**IN THE HIGH COURT OF SINDH
AT KARACHI**

C.P NO. 1879 OF 2011

**ARCHITECT'S REPORT
DATED: MAY, 21ST, 2016**

The proposed building plan on plot NO.144-A, Block-2, PECHS Karachi was approved Vide building plan No KBCA/DCB-IV/JMT/Prop/2862/137/07 dated 13-02-2007 by Karachi Building Control Authority on specified terms and conditions mentioned in approval letter in serial order from 1 to 25.

TITLE:-
GROUND FLOOR PLAN
 (8498.06Sq.Ft)

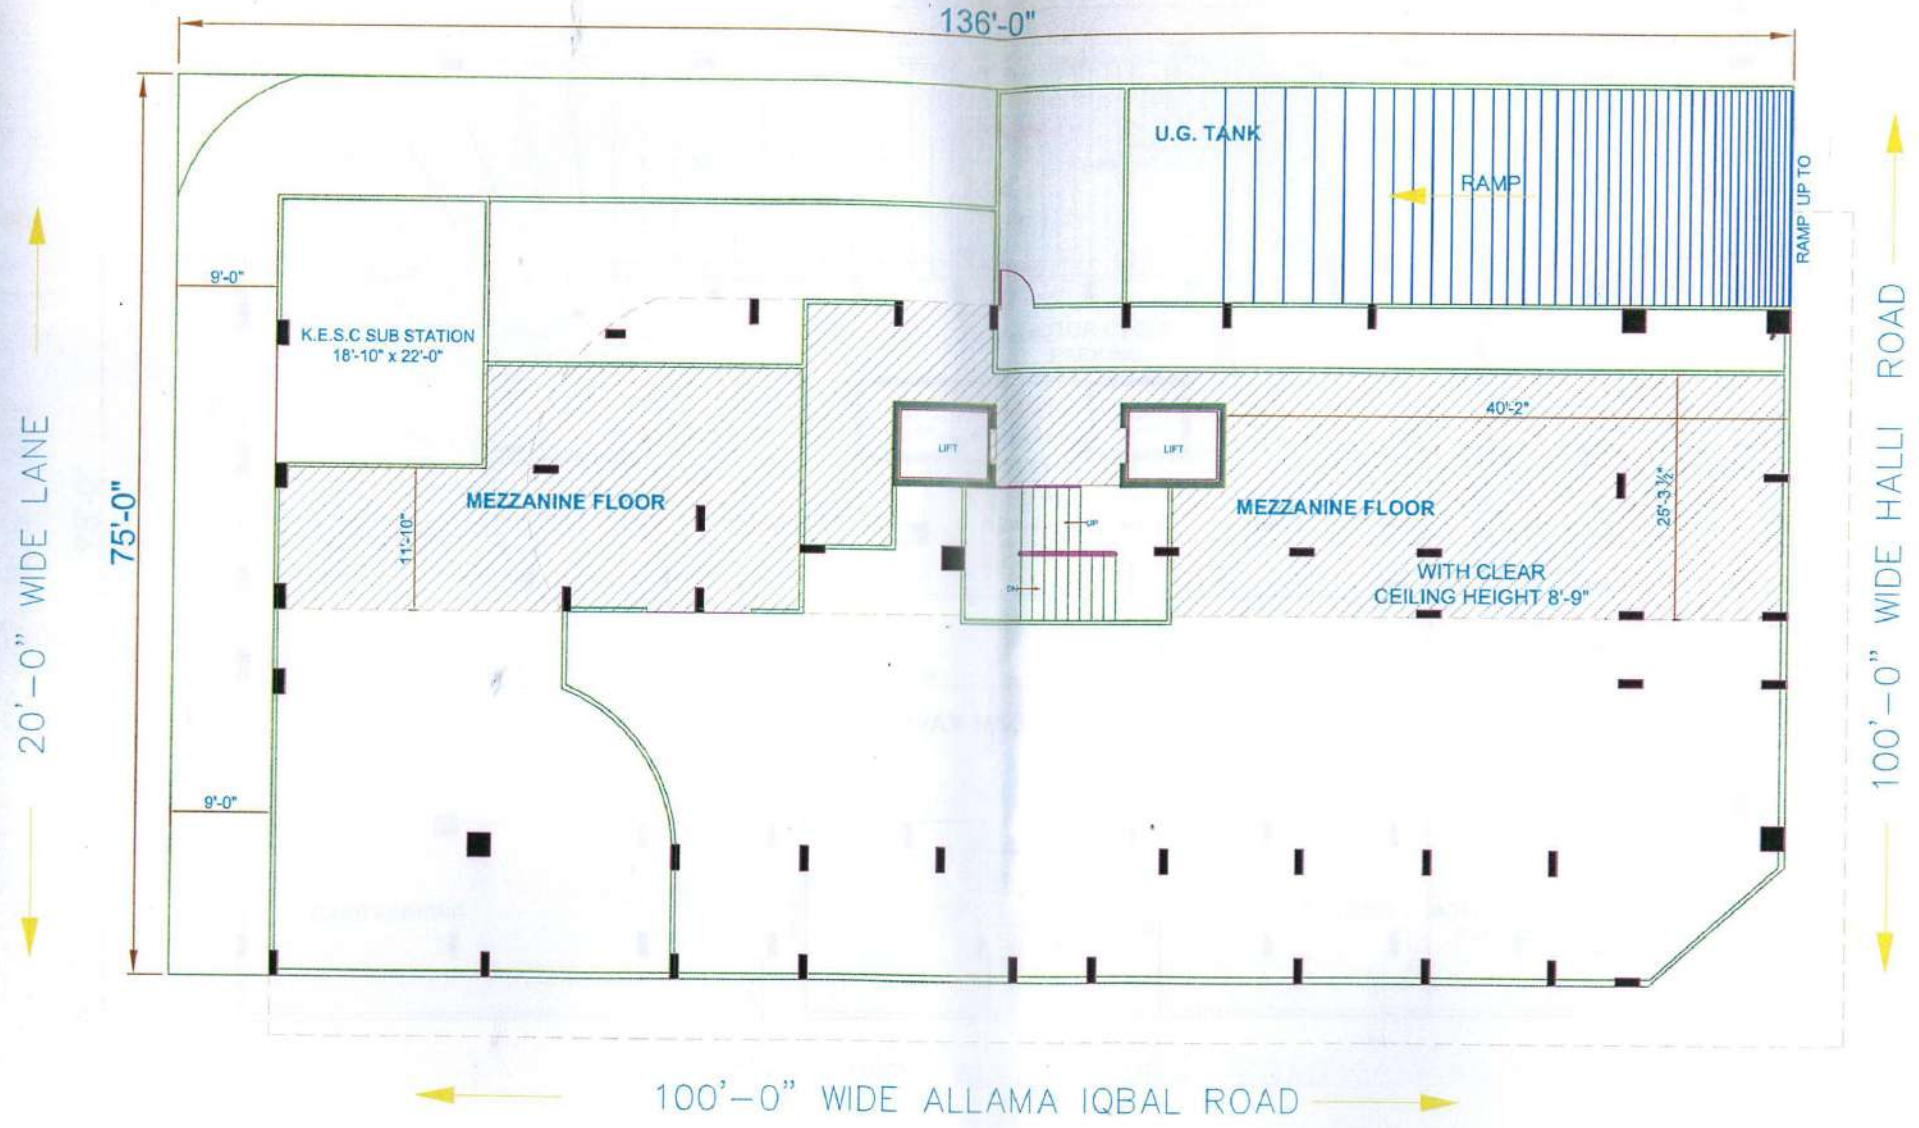
8) The allowable 8feet width of the Arcade as approved in proposed building plan was checked at ground floor and found 8feet 8inches from outer surface of shop's RCC column to outer surface of RCC columns at the peripheral plot boundaries towards both the 100feet wide roads.

9) The Arcade towards 20feet wide lane as shown in approved proposed building plan is not allowed as per KB & TP Regulations 2002 (Amdt.) 2014. The clause 25-3.2 for "Other Conditions" Stated here as under:

The said Sub-Clause clearly states that Arcade can be provided in case of lane or road not less than 40feet wide. Presently at site the lane is 20feet wide, therefore, provision of Arcade towards this sub-standard service lane shall be an irregularity as per law & therefore the entire side towards lane should be maintained as Compulsory Open Space with minimum width 7feet and no built structure or arcade thereon.

The subject plot is left with 8feet 5inches open space inside the plot towards 20feet lane, which must be maintained with minimum clear width 7feet COS from ground to top floor as per *Sub-Clause: 25-3.2{(3)}*

TITLE:-
MEZZANINE FLOOR PLAN

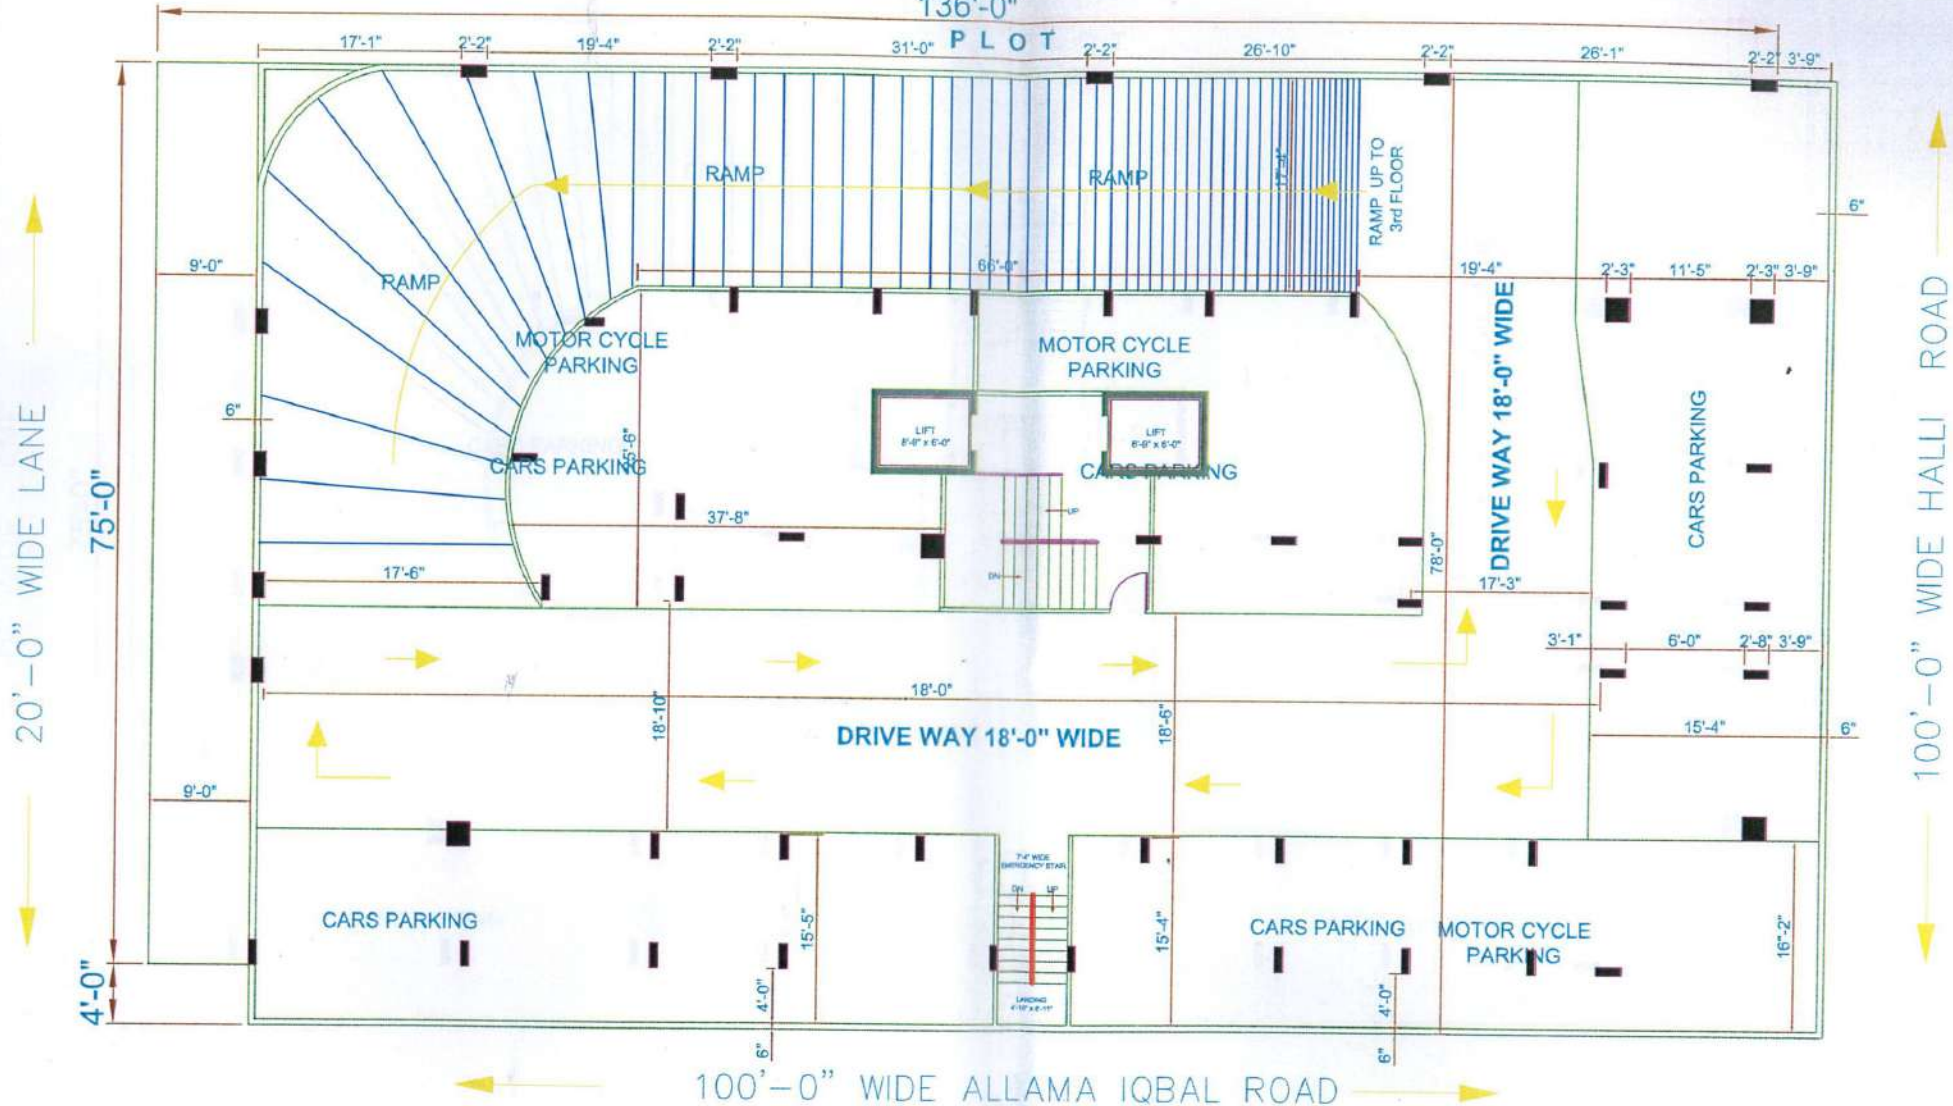
The loft converted into Mezzanine floor measured at site with total length 127feet and width 25feet 3inches as the parameters were found same as approved, but violated by illegally extended its ceiling height by 8feet 9inches instead of loft height 5feet only.

However, the existing MEZZANINE FLOOR inside ground floor above shops was noted as separate RCC floor with its clear roof ceiling height 8'.9" without partition walls and unfinished structures. The said MEZZANINE FLOOR is noticed as an un-approved floor with additional covered area in excess to the total allowable proposed area of the project.

- 43) The Mezzanine floor was constructed as illegally built floor by mis-use of 40% loft area above shops. The existing covered area of Mezzanine was measured and found 2460.46sqft. The illegally built mezzanine floor having status of separate floor shall be considered as un-authorized FLOOR in VIOLATION of approved building plan & allowable Floor Area Ratio in respect of covered area.

TITLE:-
1st & 2nd FLOOR PARKING PLAN

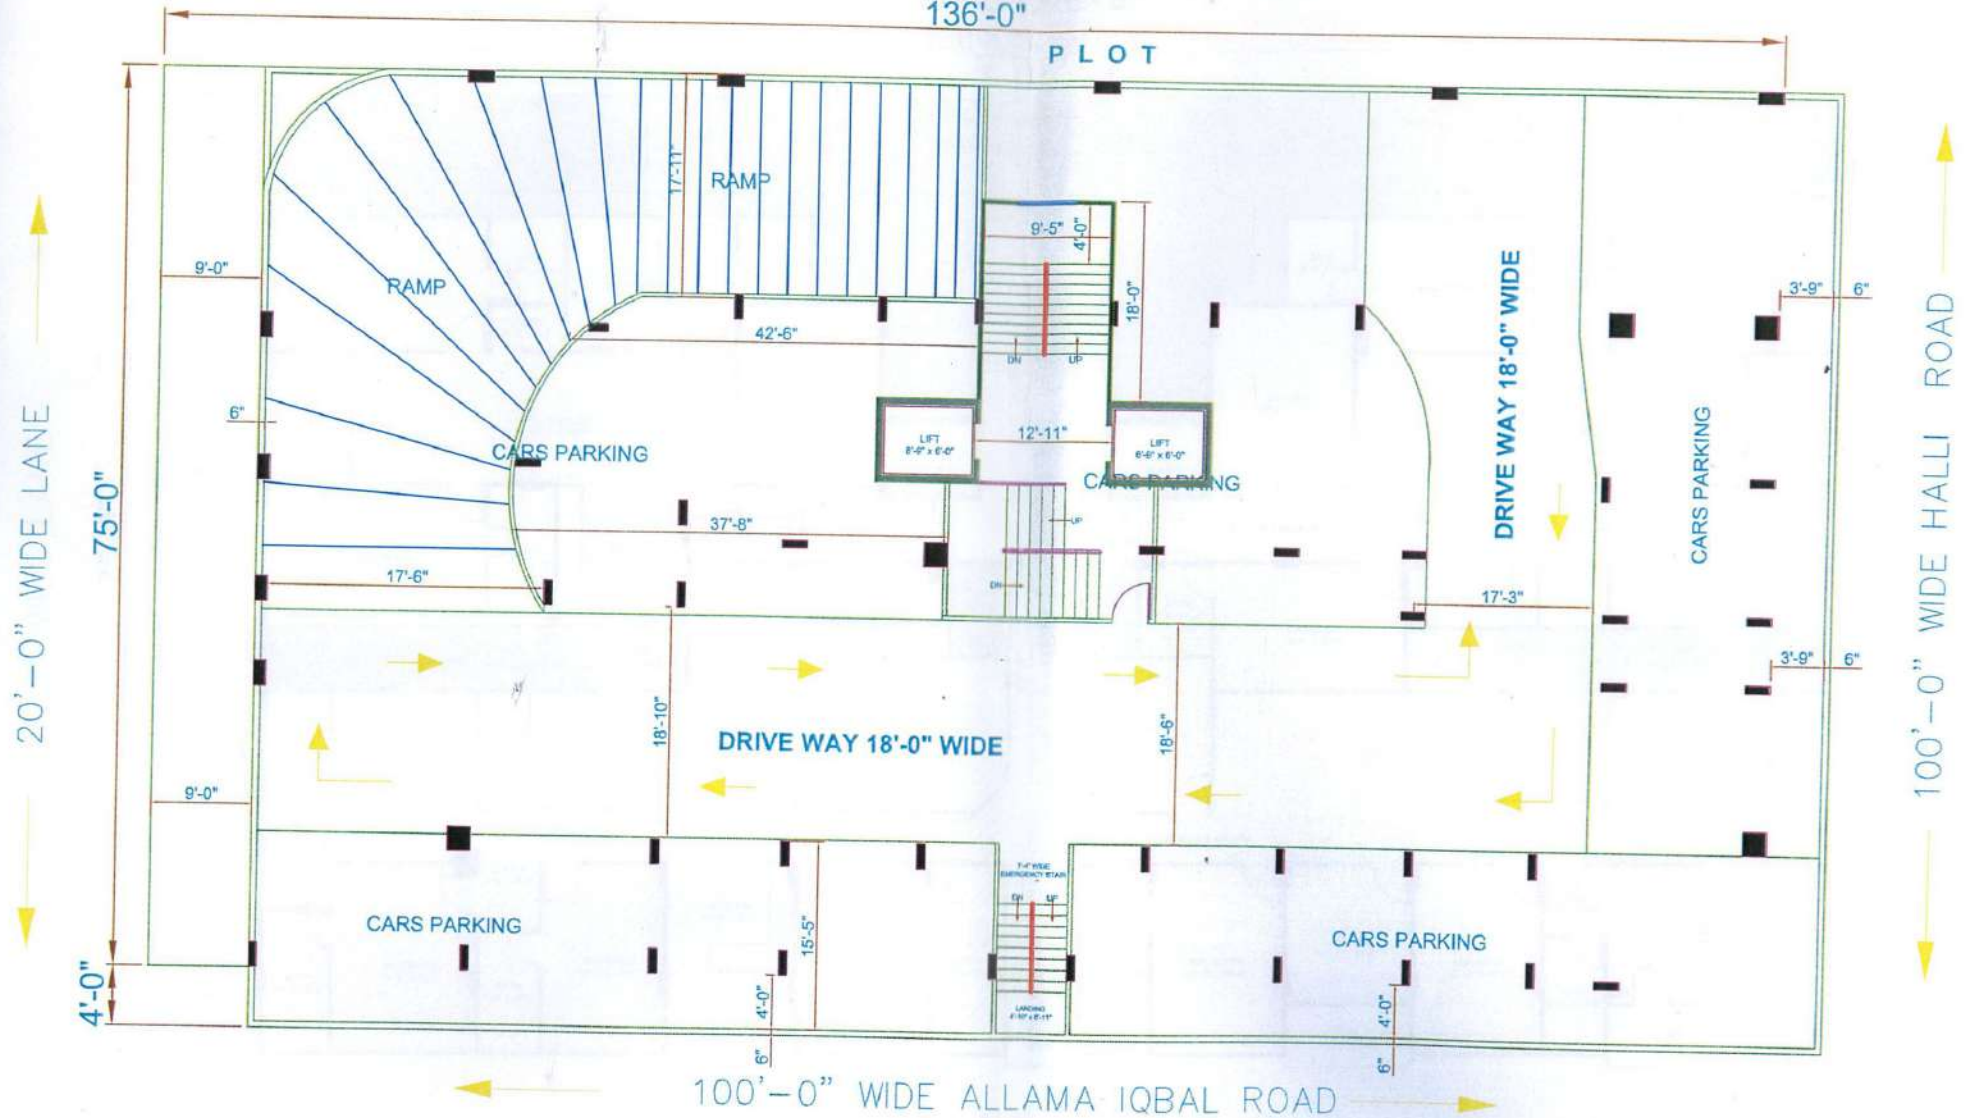
The drive way width of parking floors varies from minimum 18feet 6inches to maximum 19feet 4inches. Whereas, it was noted only 17feet 6inches in between the two opposite RCC columns opposite to each other on the driveway at its first left turning at 90 degrees same on all the three car parking floors.

Similarly, it was noted only 17feet 4inches width in between the two opposite RCC columns at the entrance to Ramp upwards from first to second floor and same clear width at the ramp entrance from second to third floor.

The length of the car parking bays along with drive way towards both the major roads varies and measured as minimum 14feet 8inches or 15feet 3inches at some places/bays which is sub-standard as required a clear 16feet length.

- 23) The garbage chute & collector provision not provided by making certain infrastructure/hole in RCC roof slab on 1ST, 2ND & 3RD floor car parkings as shown in approved proposed building plan.

TITLE:-
4th FLOOR FLATS PLAN

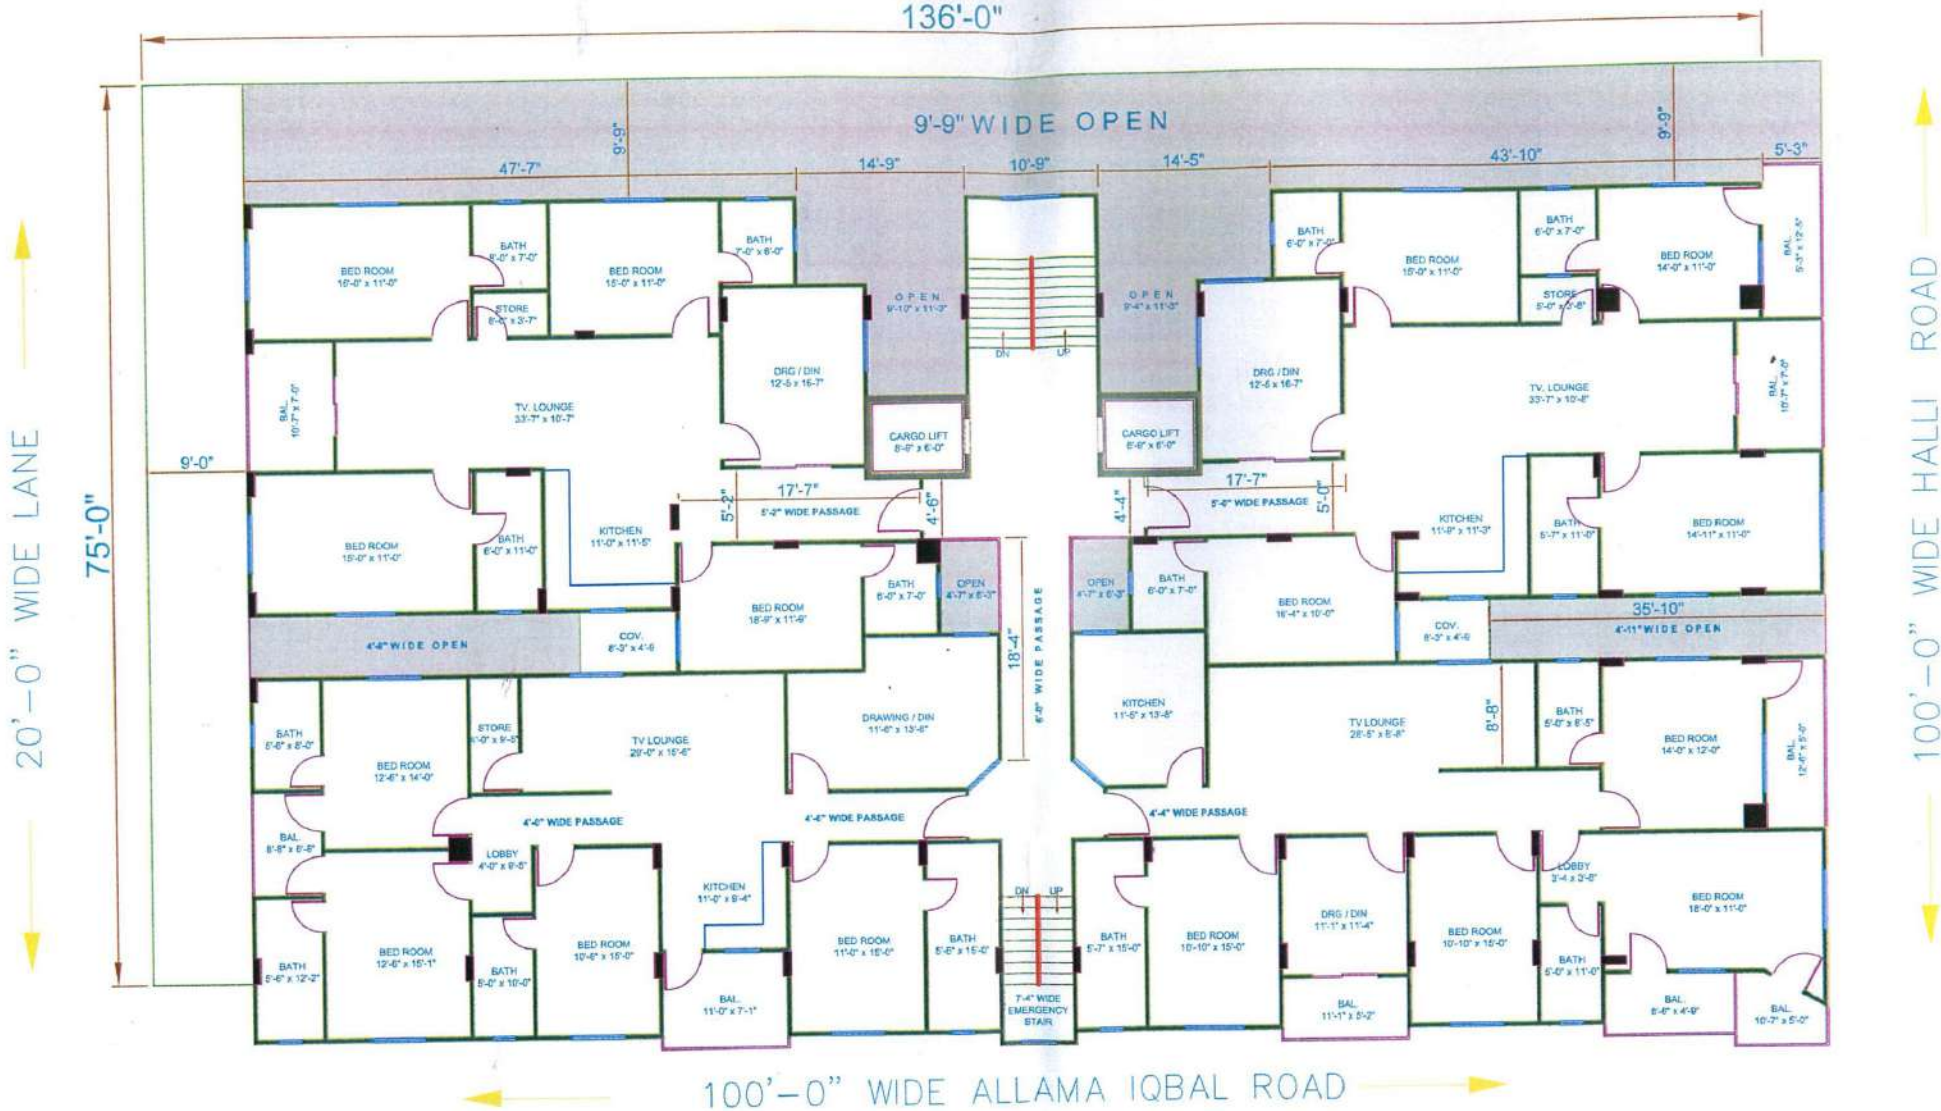
In contrary to the 4TH Floor approved layout, the above mentioned Recreation area was found as constructed with same typical design and layout of four bed room flat.

Besides, the major open to sky two big air wells located internally near service lobby opposite to each other were almost completely closed for illegal extension of all the four existing flats.

As earlier briefly mentioned the Recreation area as approved 2% in proposed building plan shown in "Schedule of Area" Sheet No.AR-03/03 i.e.1190.01square feet, was completely occupied by illegal construction of unapproved flat on left side front corner of 4TH floor facing Allama Iqbal road.

- 24) The 2% Recreation Area approved in proposed building plan of 4TH floor at the corner facing Allama Iqbal road was totally violated by illegal construction of flat.

NOTE:
PROPOSED RECREATION 2% ON LEFT SIDE
CORNER ON FRONT CONVERTED TO FLAT
